Department of the Army
New York District
Corps of Engineers
New York, New York 10278-0090

AMENDMENT NO. 3 DATED AUGUST 22, 2005 FOR MICHIE STADIUM, WEST POINT
MILITARY ACADEMY, NY

A4-02 RESTORATION DETAILS: TYPICAL
CONCRETE DETAILS, SHEET 2

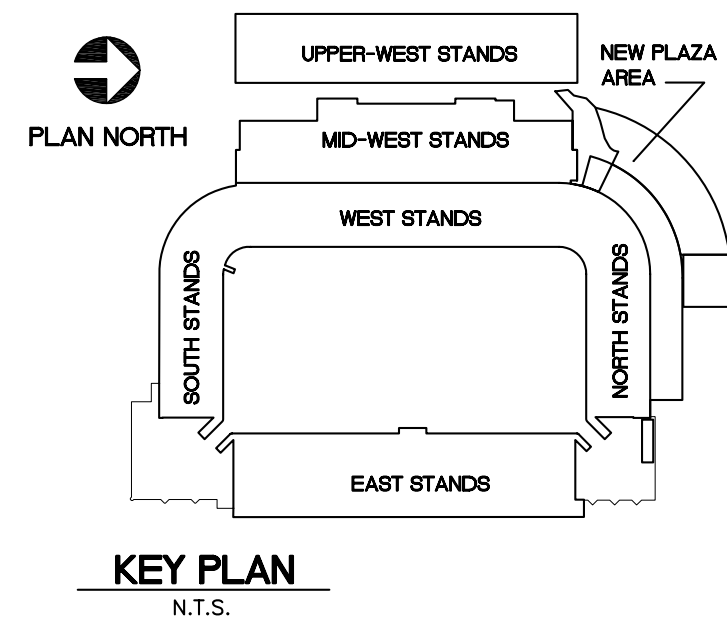
1. CONTRACTOR TO REMOVE, MARK, STORE AND PROTECT BENCHES. THEY MUST BE REINSTALLED IN THEIR ORIGINAL LOCATIONS, WITH EXCEPTIONS: ASSUME THAT 5% OF THE SEATING STANCHIONS WILL BREAK DURING REMOVAL OPERATIONS AND WILL HAVE TO BE REPLACED. THE COST FOR THIS MUST BE INCLUDED IN THE BID.

NOTE:
IN CASE OF BOLT RELOCATION, OLD BOLT IS TO
BE ENTIRELY REMOVED AS PER DETAIL 1A/A4-01.
HOLE IS TO BE PATCHED AS PER SD REPAIRS C
DWG A4-01.
